HISTORIC PRESERVATION BOARD MEETING

**PUBLIC HEARING
58 FORE STREET, PORTLAND COMPANY HISTORIC DISTRICT**

TO: Chair Sheridan and Members of the Historic Preservation Board
FROM: Deb Andrews, Historic Preservation Program Manager
DATE: February 25, 2020
RE: March 4, 2020 **PUBLIC HEARING**

Application for: Approval of outstanding design details and specifications for
Building 12, 1A and Grand Stairs

EXCERPTS FROM
9/18/19 PUBLIC
HEARING.

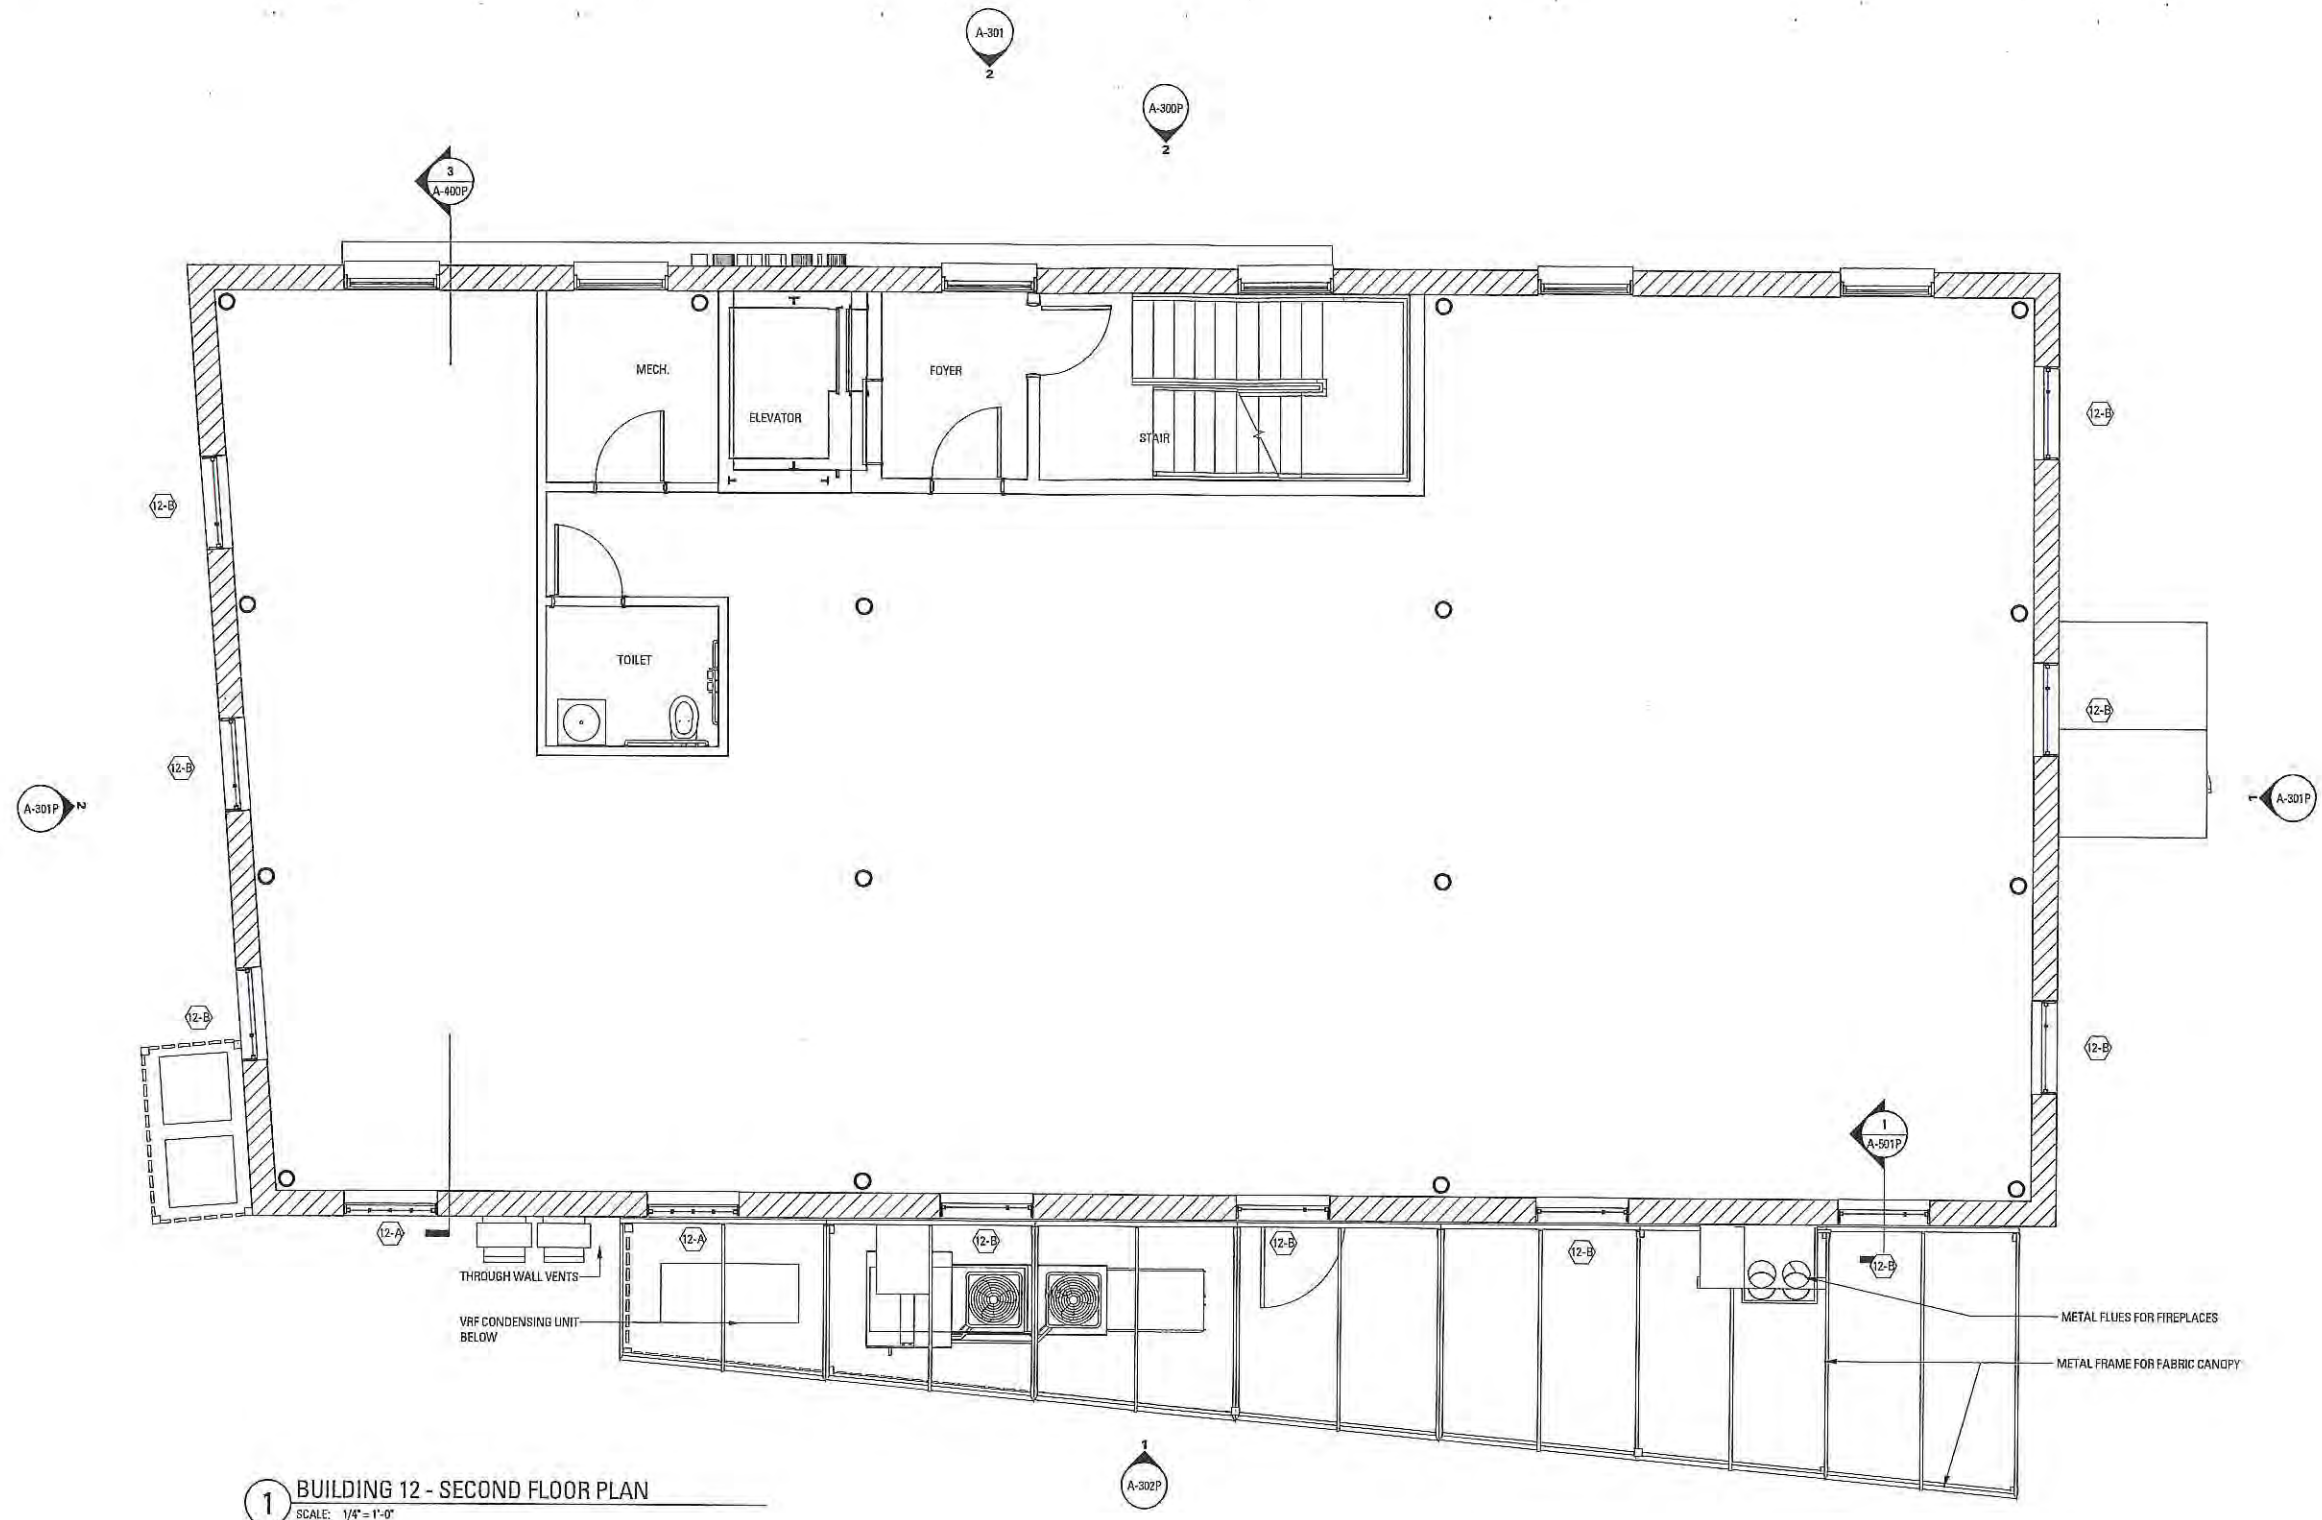
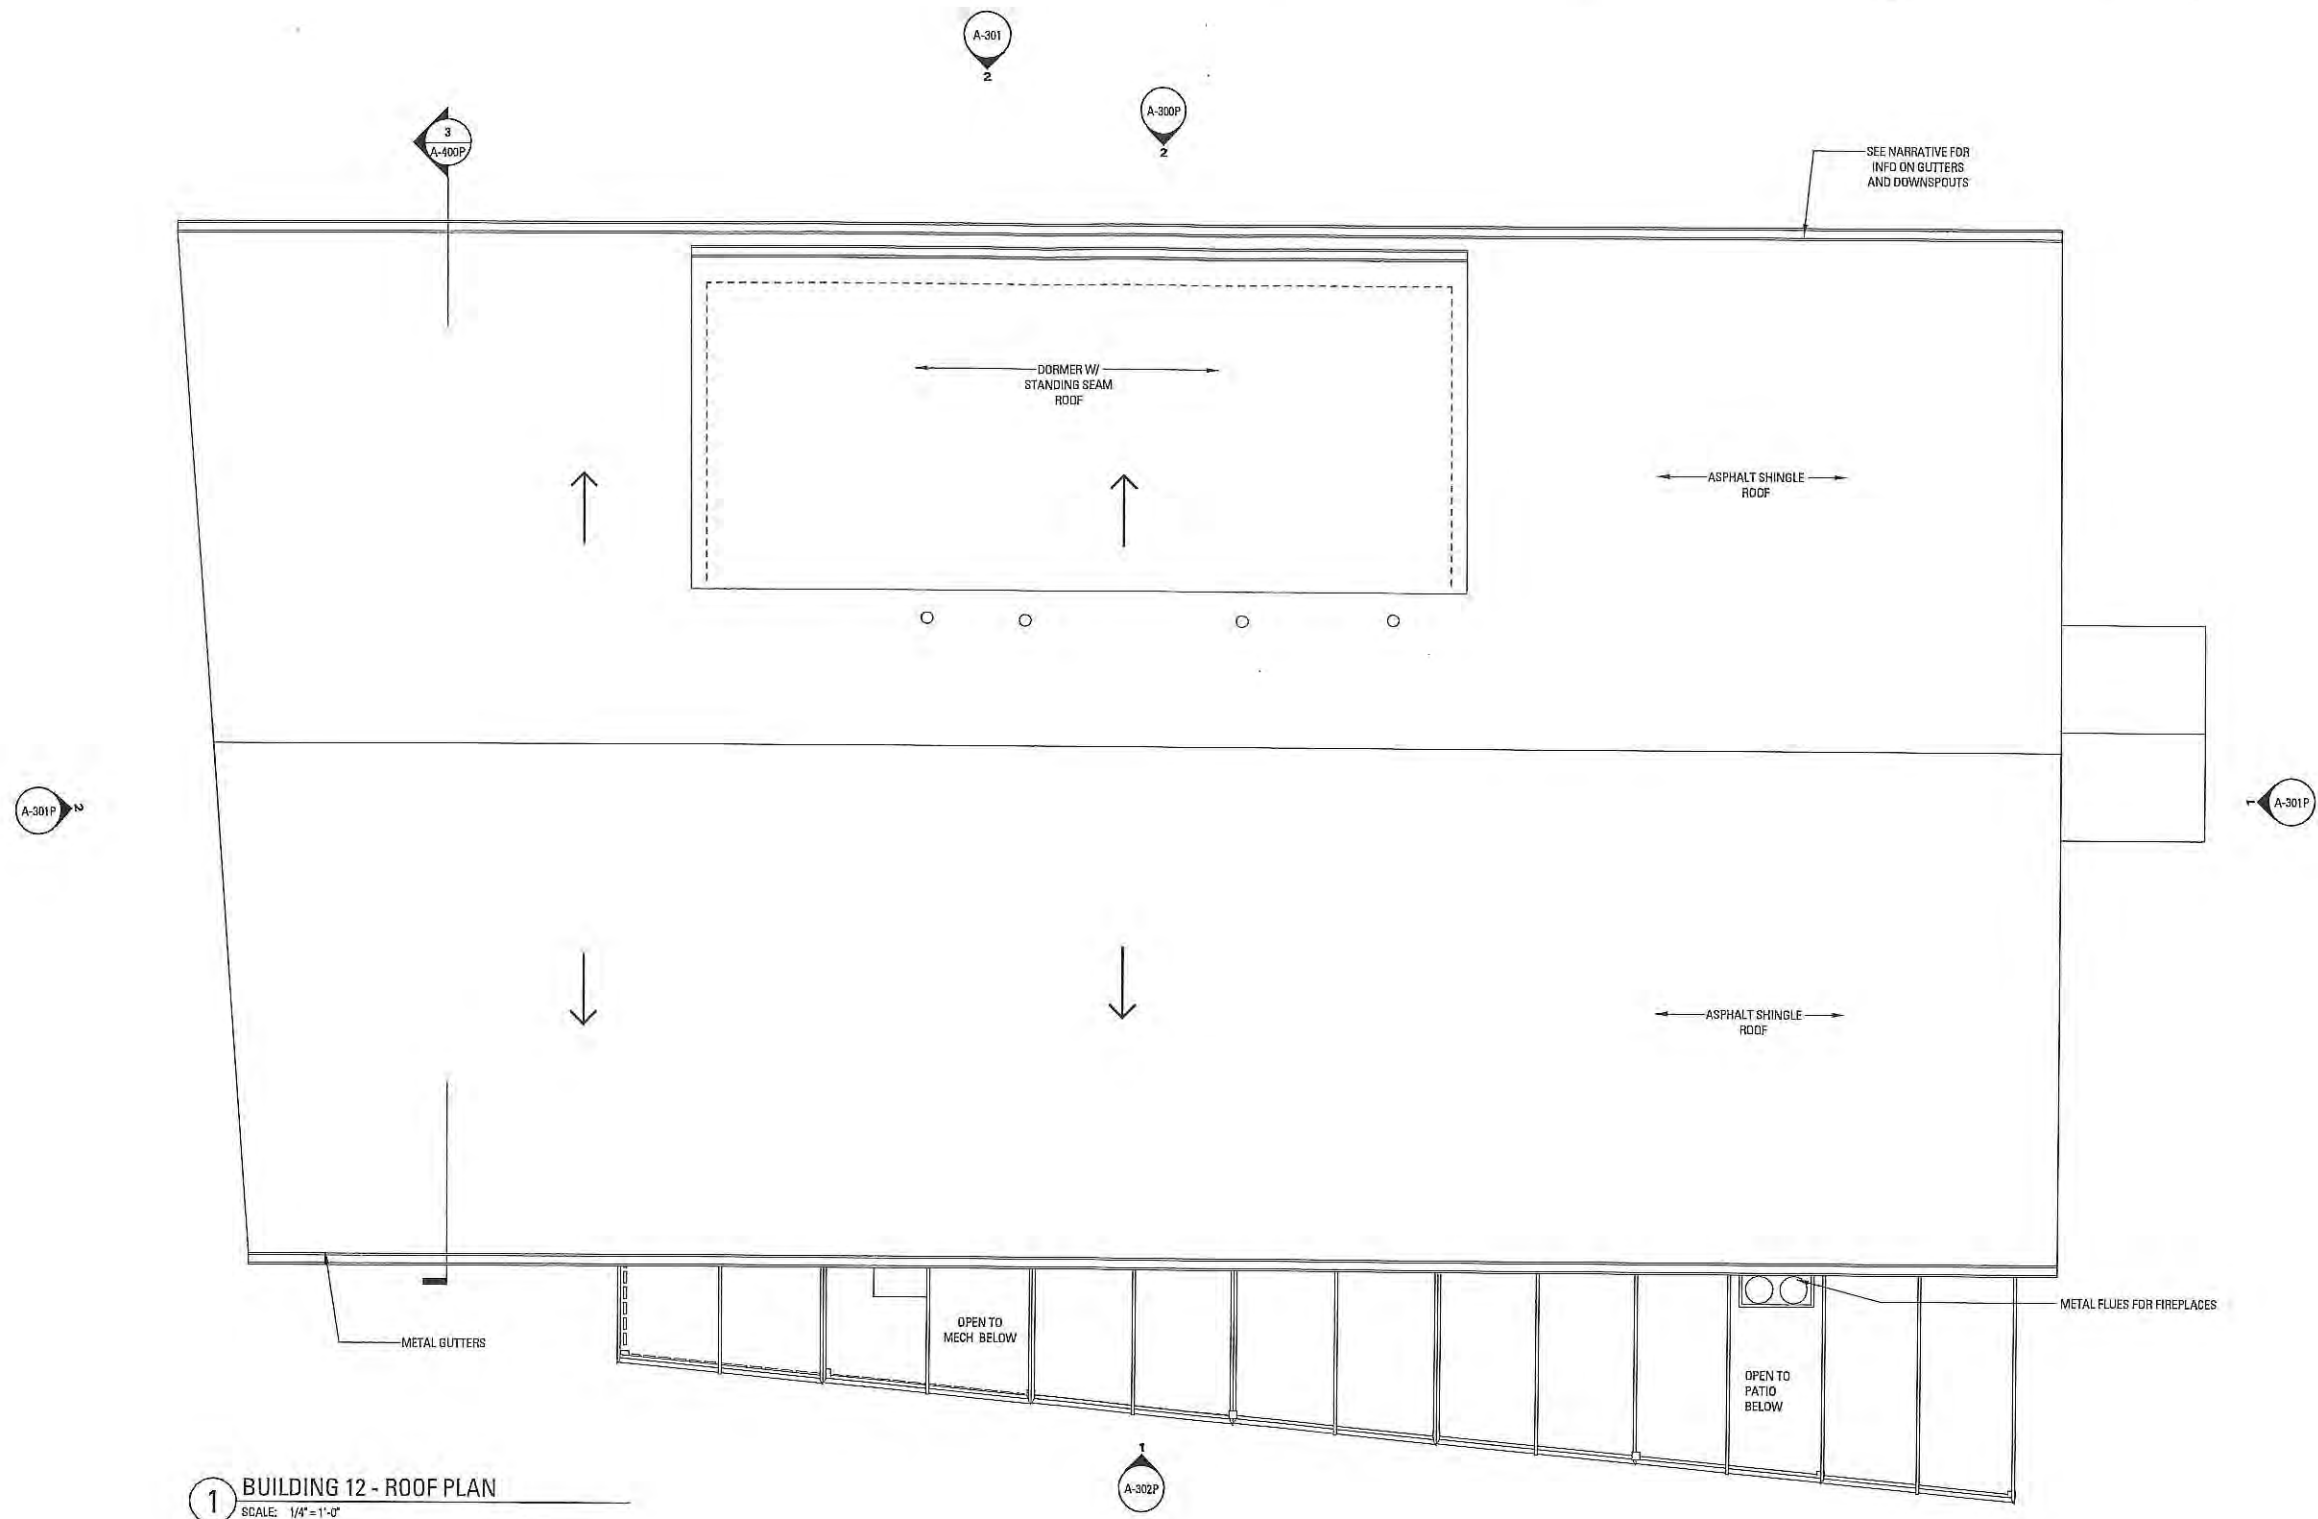
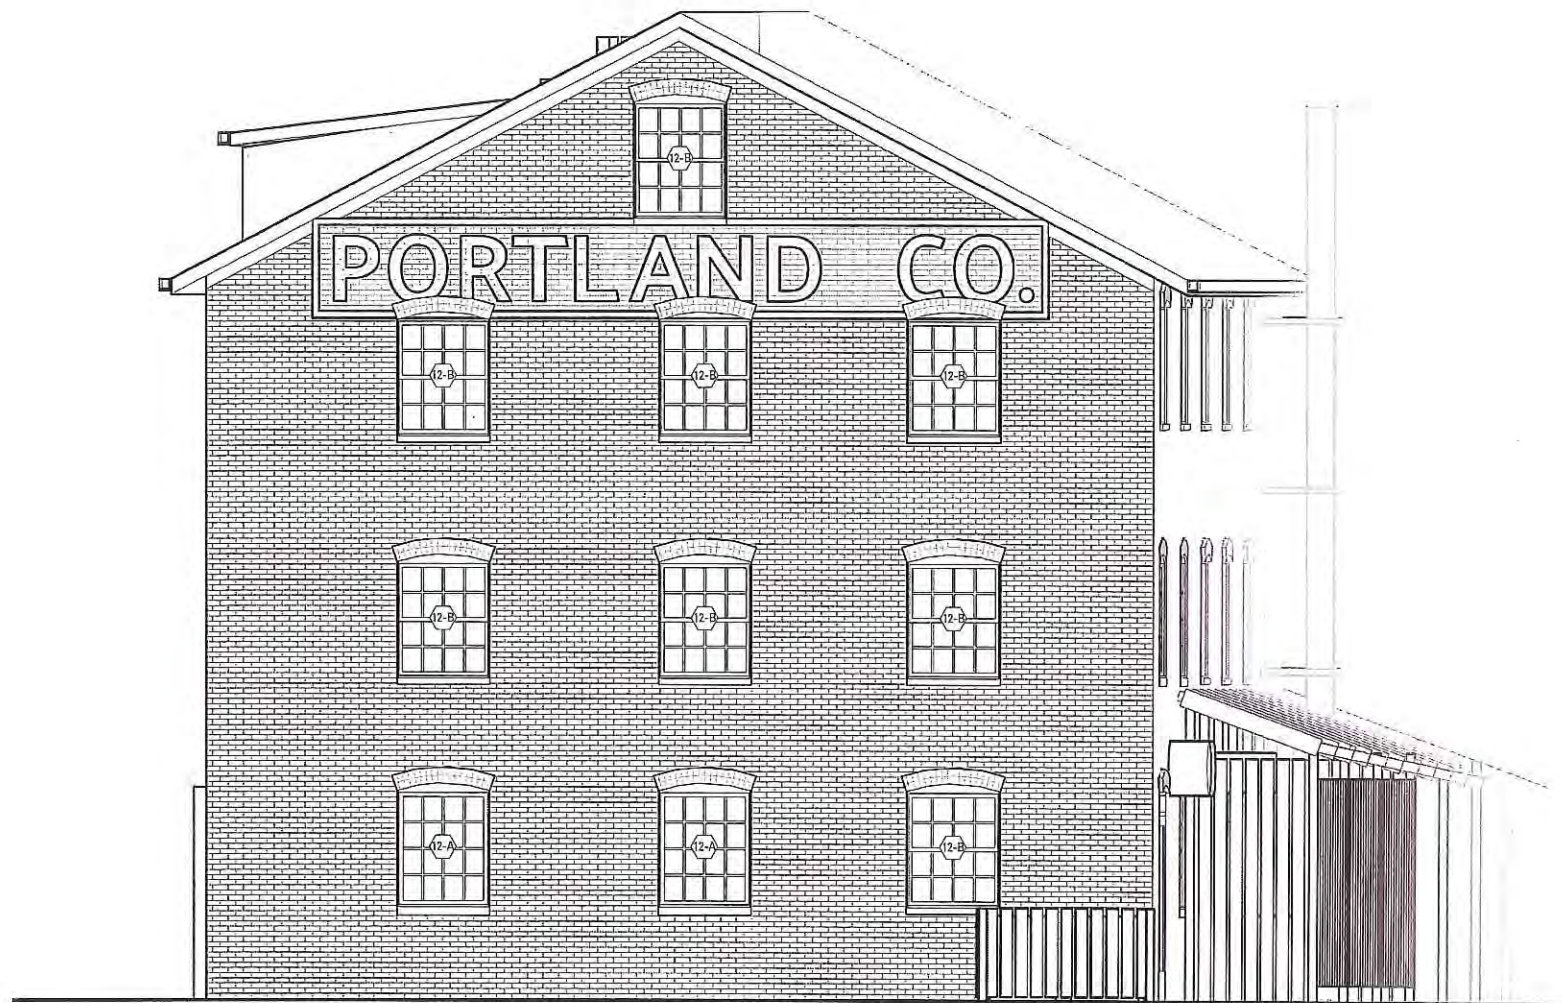
Note that there have been some minor changes to the plans since it was approved last September. Comparing original (ATT. 5) and current elevations, staff notes the following adjustments on the south elevation:
